## SERVICE BULLETIN

This service bulletins affects all Zombie Revenge U/R games

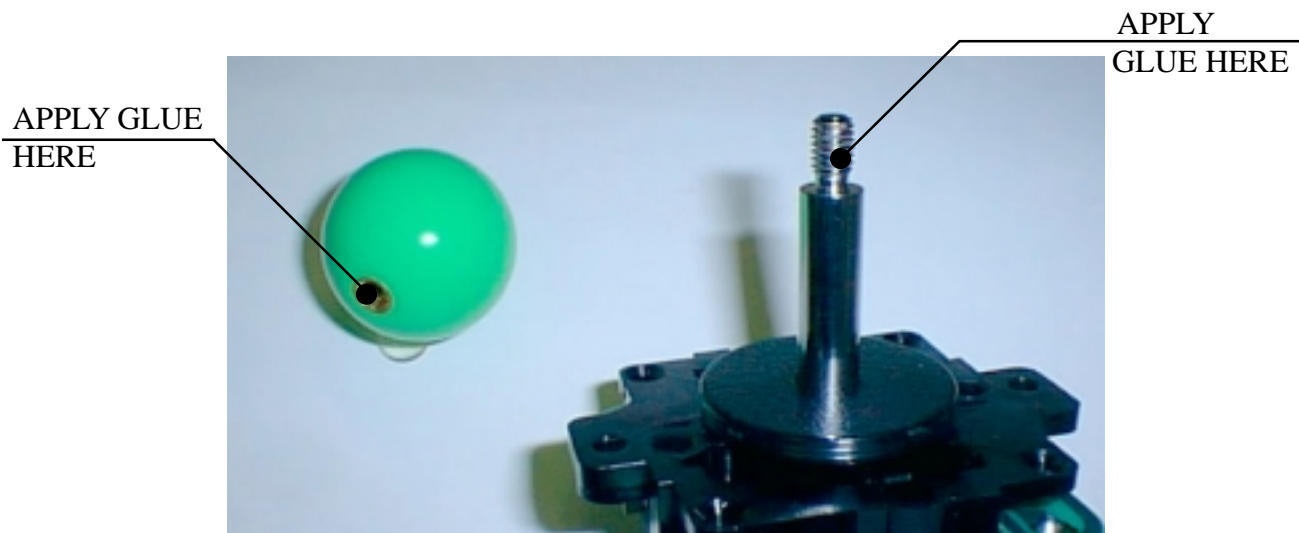
**Problem: Joystick knobs work loose and are unscrewed by players during game play.**

**Solution: Secure the joystick knob to the shaft by using the steps below:**

- 1.) Unscrew and remove the joystick knob from the shaft.
- 2.) Clean all threads.
- 3.) Apply super glue(cyanoacrylate) to the threaded hole in the knob.
- 4.) Re-apply the knob to the shaft and tighten allow 10-15 min for glue to dry.

USE GLUE SPARINGLY! (It is not necessary to apply glue to both portions)
